## City of Phoenix PLANNING AND DEVELOPMENT DEPARTMENT

### Staff Report Z-6-19-1 September 4, 2019

**Request To:** RE-35 Hillside DNS/WVR (Single-Family Residence District, Hillside Density Waiver) (60.50 acres)

Figure H. Maximum Gradable Elevation, 1610' Above Mean Sea Level

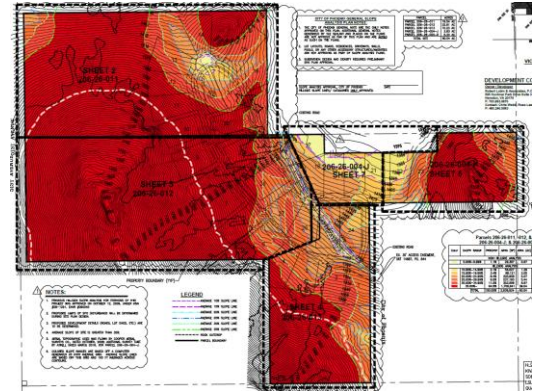
- A maximum building envelope disturbance area of 400,000 square feet. Stipulation No. 2.
  - Section 710 would restrict grading to a maximum of 35% of the total site area or 20,000 square feet per unit; the disturbance maximum proposed is based on the allowed per unit disturbance of 20 units, rather than the 32 requested.
- A maximum elevation for grading disturbance of 1,610 feet above mean sea level. Stipulation No. 4.

4. There shall be no grading permitted at an elevation of 1,610 feet above mean sea level or above. The remainder of land shall remain undisturbed and be preserved as natural desert open space, as approved by the Planning and Development Department.
5. The color and material palette for the buildings shall be determined at site plan

Figure L. Proposed Off-Site Improvements

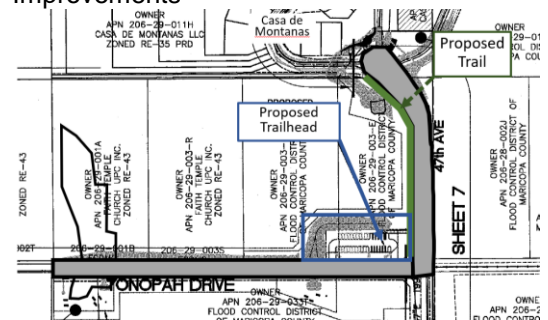
The conceptual site plans also propose: the completion of Tonopah Drive from its current terminus to 47th Avenue to provide another access; the construction of a bicycle and pedestrian trailhead at the northwest corner of 47th Avenue and Tonopah Drive; and the construction of a 10-foot “detached trail” to where the service road deviates toward the Adobe Dam. These off-site improvements are depicted in Figure L.

The proposed improvements depict a “10-foot detached sidewalk” at the above location; however, staff recommends the pedestrian route comply with the specifications of a multi-use trail easement and trail.

Figure M. Typical Elevation (Uphill Prototype Elevation)

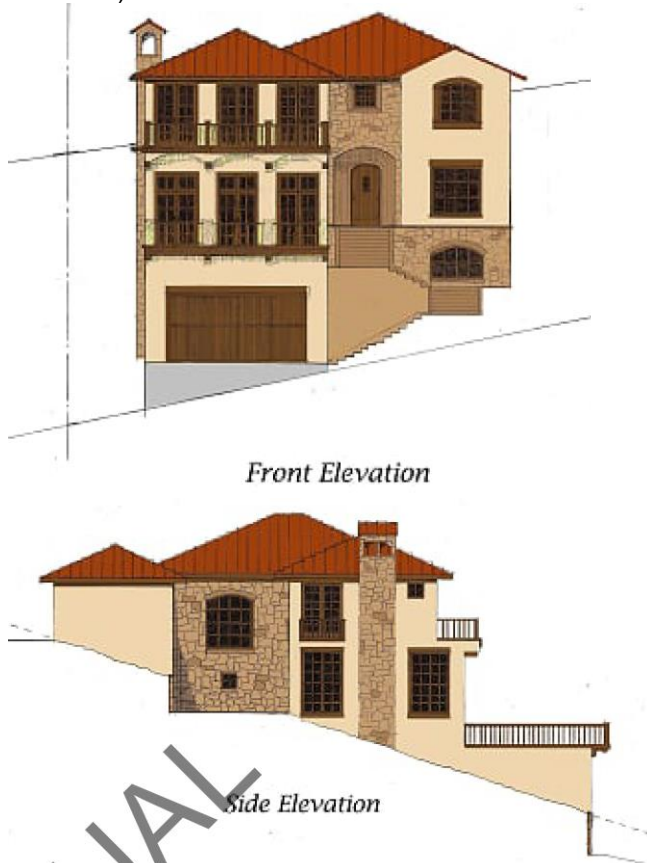
The height requirement of Section 710 is a maximum of two-stories, not to exceed 30-feet above natural grade. It appears several of the conceptual elevations may not comply with this requirement.
